MEMORANDUM

TO Brad and Kathy Bettman PROJECT 415 Bush Street, Mountain View

REGARDING 415 Bush Street, Mountain View – Secretary of the Interior's Standards for

Rehabilitation Compliance Analysis

Figure 16. Proposed site plan. Rear addition and alterations indicated by red shading and outline. Source: "Proposed Remodel For: The Bettman Residence" prepared by Flury Bryant Design Group, Inc. (dated July 16, 2024), Sheet 2. Edited by Page & Turnbull.

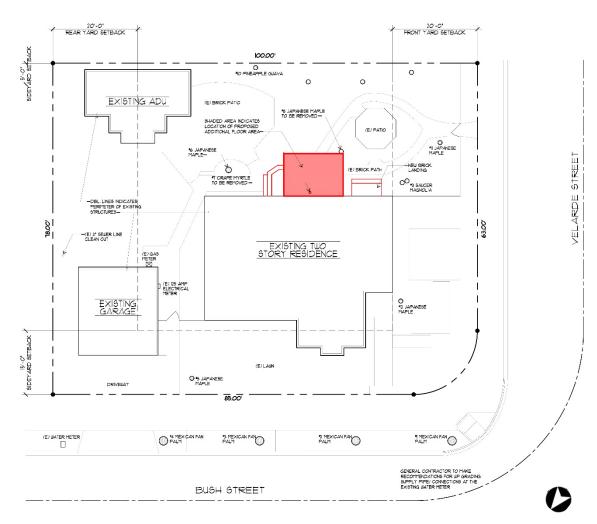
- A one-story, 136-square-foot addition would be constructed at the rear (east) side of the
 residence, with stucco siding, wood siding at the gable end, and standing seam metal roof
 cladding.
 - An existing French door; non-original wood canopy; masonry stoop, and non-original wood sash double-hung window would be removed
 - o A new masonry stoop and double-hung wood sash window would be installed at the right (north) side of the new addition
- A pair of original double-hung wood sash windows at the leftmost (south) side of the east façade would be removed and replaced with a new set of French doors, wood canopy, and brick stoop.

The proposed project includes a one-story, 136-square-foot addition at the rear (east) side of the residence. The addition would replace and relocate a non-original set of French doors with wood canopy to another location on the same façade in the place of a pair of existing original wood sash double-hung windows. The addition and alterations are proposed for the rear east façade, which is not visible from the public right-of-way, despite the property being a corner lot. Thus, the location and design of the addition and alterations would affect a minimal amount of historic material and would not diminish the historic character of the residence. The new addition would be clad in stucco and horizontal wood siding to match the existing residence, and the standing seam metal roofing would sufficiently distinguish it as an addition. The new set of French doors would feature a wood canopy with curved brackets that would be differentiated from existing wood brackets elsewhere on the building and would not introduce a sense of false historicity.

Page & Turnbull appreciates that the proposed project design largely respects the historic design and architectural style of the building by retaining the majority of character-defining materials and features, and that the proposed addition is compatible in scale and located at the rear façade and not visible from the public right-of-way. To improve the compatibility of the project, Page & Turnbull recommends that the proposed standing seam metal roofing be finished in a non-reflective brown tone or similar color.
